City of Sebastopol Design Review Board Staff Report

Meeting Date: April 6th, 2022
Agenda Item: 6B
To: Design Review Board
From: John Jay, Associate Planner

Subject: Design Review
Recommendation: Approval with conditions
Applicant/Owner: Elizabeth Valerio/Starbucks
File Number: 2022-001
Address: 700 Gravenstein Highway North
CEQA Status: Exempt
General Plan: Office Commercial (CO)
Zoning: General Commercial (CG)

Below is the current site configuration:

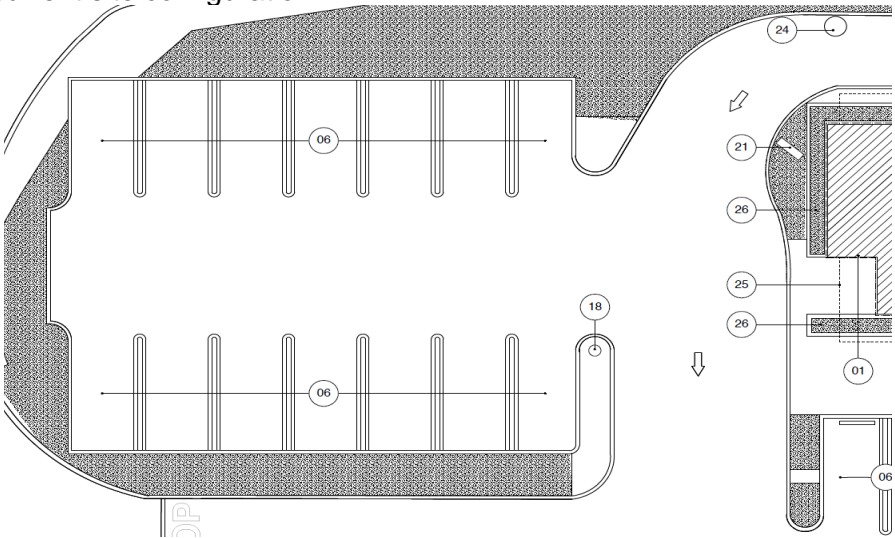
The applicant is also proposing parking modifications to the overflow parking lot to the north. Staff feels that this modification is well needed with the relocation of drive thru window. Currently, the parking lot is accessed off the exiting of the drive thru window in its current eastern location. However, when the window change is made this layout will be confusing and cumbersome to patrons exiting the window. The applicant is provided a plan to deal with this potential hurdle on sheet 3 of the project plan set. The plan would be to install a curb along the parking lot running east to west which would funnel the traffic into the main flow of the shopping center.

Below is what is proposed.

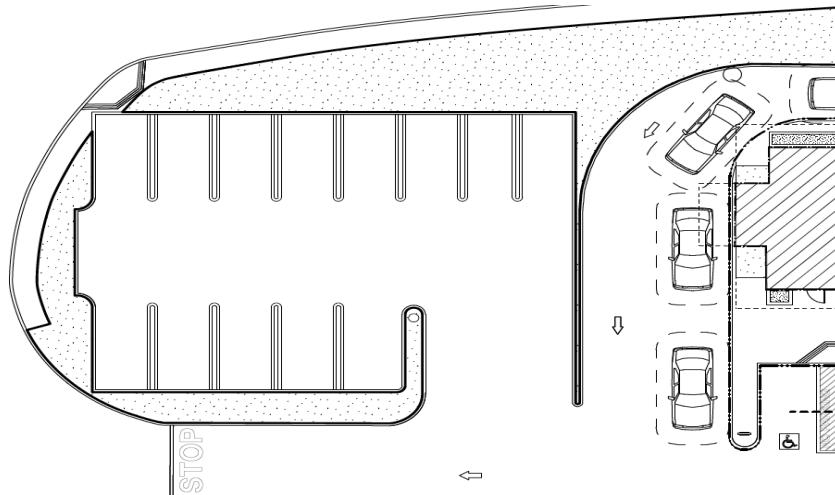
This parking modification will help with traffic queuing in that, if the parking area was kept in place, it could cause potential backups and disrupt the flow of traffic in and out of the drive through lane.

The window's current location allows for roughly 6 cars to be in queue whereas the new orientation would allow for 10 cars thus allowing for a better flow of traffic through the shopping center and the proposed use. Currently, overflow traffic to the existing drive through backs up into the drive aisles of the shopping center (in front of the Verizon / Postal Annex store) and/or the alley south of the restaurant. The change to the queue would reduce, and may eliminate, this issue. Therefore, staff believes Section 17.110.020.E, item 9 can be met given the improvements to traffic likely by the revised configuration of both the drive through queue and the separation of this traffic from the parking area.
